**SUBJECT LAND: 130 Gwynne Street, Cremorne**

Planning Application No:	PLN18/0945	Date: 16/4/19
Subject Site:	130 Gwynne Street, Cremorne	
Responsible Planner:	Gary O'Reilly	
ESD Advisor:	Scott Willey	
Project Description:	Development of the land for the construction of a triple storey dwelling with a basement and roof terrace	
Site Area:	136m <sup>2</sup>	Site Coverage: high
Pre-application meetings:	-

**To:** Gary O'Reilly  
**From:** Artemis Bacani  
**Date:** 12 September 2019  
**Subject:** Application No: PLN18/0945  
 Description: Amended Plans  
 Site Address: 130 Gwynne Street, Cremorne

**TO: Gary O'Reilly**  
**FROM: David Pryor**  
**DATE: 7 August 2019**  
**SUBJECT: 130 Gwynne St Cremorne**  
**APPLICATION NO: PLN18/0945**  
**DESCRIPTION: Amended proposal for a triple storey dwelling with a basement**

PROJECT	130 GWYNNE STREET CREMORNE	
CLIENT	R LAROSA	
TITLE	GROUND FLOOR	PROJECT NO. 1803
DWG NO.	1803-IP06	SCALE 1:100 A3
		REV. D

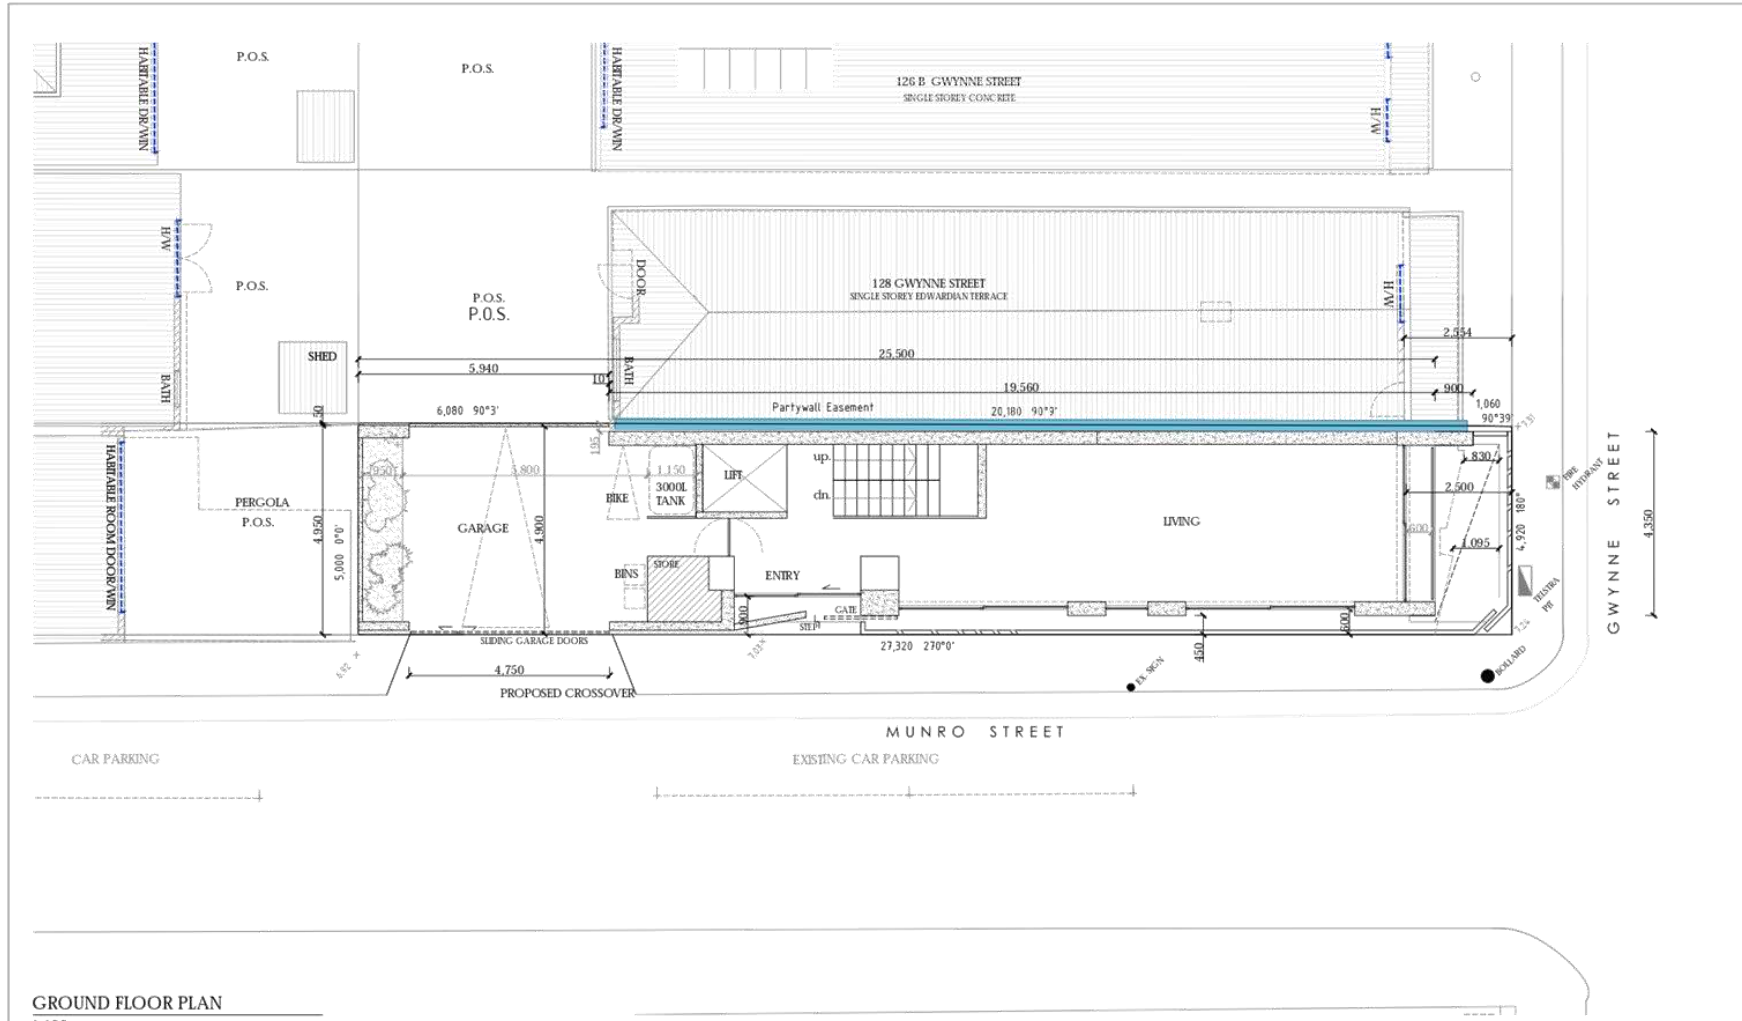
C McFadyen Design Drawing No. 1803-TP06 Revision D dated 24 June 2019

Item	Assessment
<b>Access Arrangements</b>	
Garage Doorway Width	The proposed garage doorway width is 4.75 metres.
Vehicle Crossing	The proposed vehicle crossing is also 4.75 metres in width.
<b>Car Parking Module</b>	
Garage	<p>A minimum unobstructed internal depth of 5.4 metres is required to satisfy AS/NZS 2890.1:2004.</p> <p>In this instance, the depth of the garage is considered insufficient to accommodate a B85 design vehicle.</p>

Item	Details
Vehicle Crossing	Council will not issue a vehicle crossing permit unless the garage dimensions is suitable to accommodate a B85 design vehicle and has the minimum internal dimensions of the garage satisfies the requirements of AS/NZS 2890.1:2004.

SOUTH ELEVATION - MUNRO STREET  
1:100

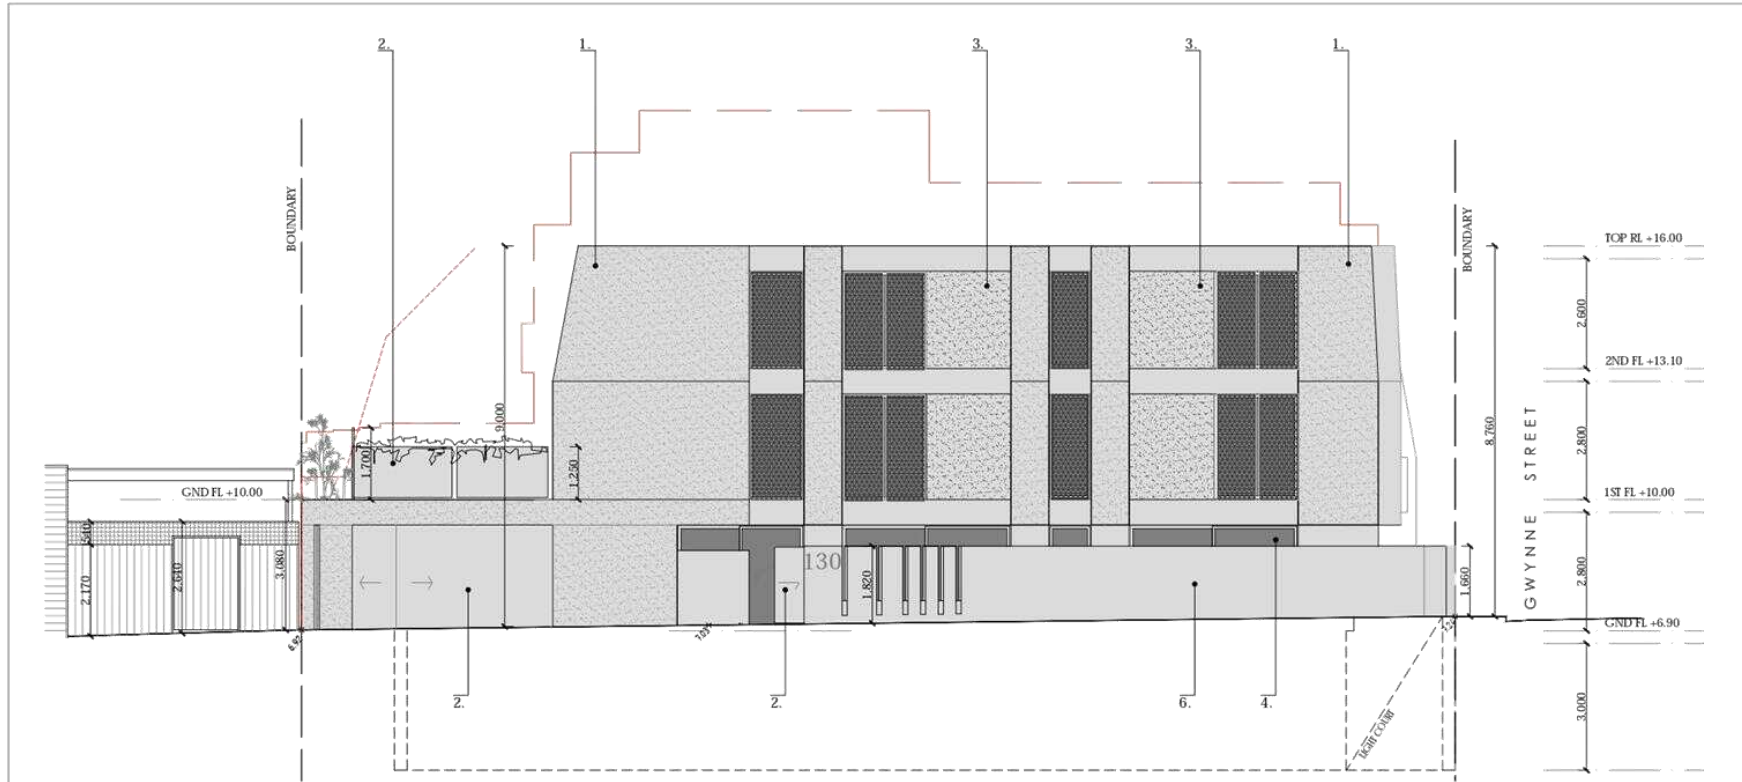
- The south elevation has been lowered, modified and animated by means of movable screens, and is now supported (subject to the clarifications below).
- The wing wall at the northeast corner had been better integrated and is now acceptable.

NORTH ELEVATION - MUNRO STREET  
1:100

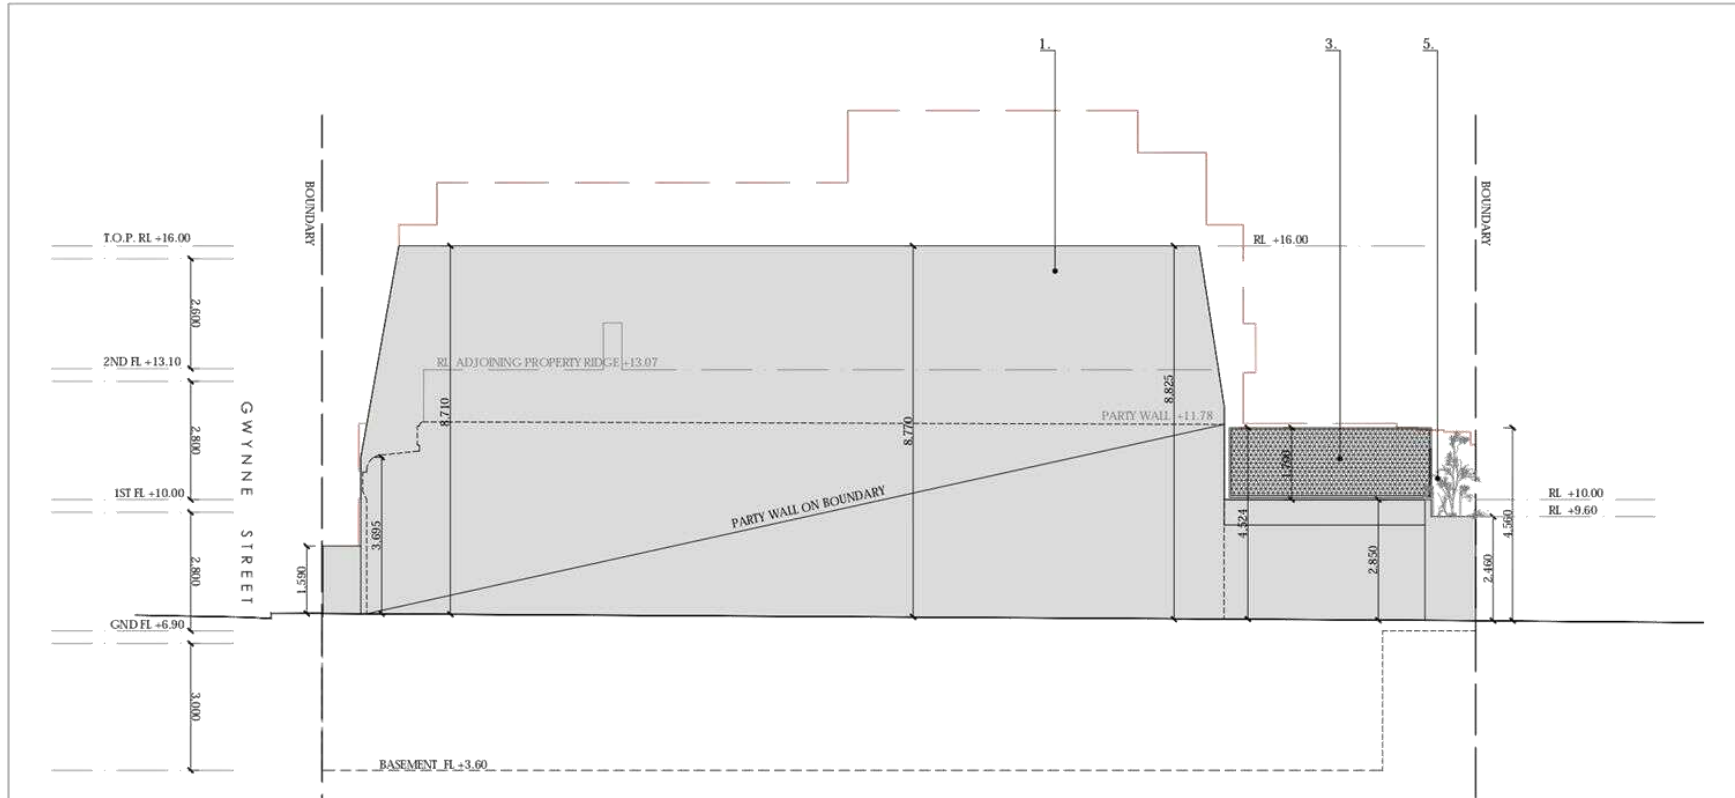
- The change from bronze to copper cladding is supported.
- There are some ambiguities in the elevations. The north elevation is noted as roughcast, but lacks the texture shown on the rest of the roughcast. There appear to be slits in the concrete fence, but these are not noted or dimensioned. The RFI response refers to copper cladding on the south elevation – presumably in the locations labelled “3” but textured like roughcast on TP11; it seems that these panels should be labelled “2”, the actual screens should be labelled “3”, and these screens should be shown as sliding/openable, consistent with the plans.
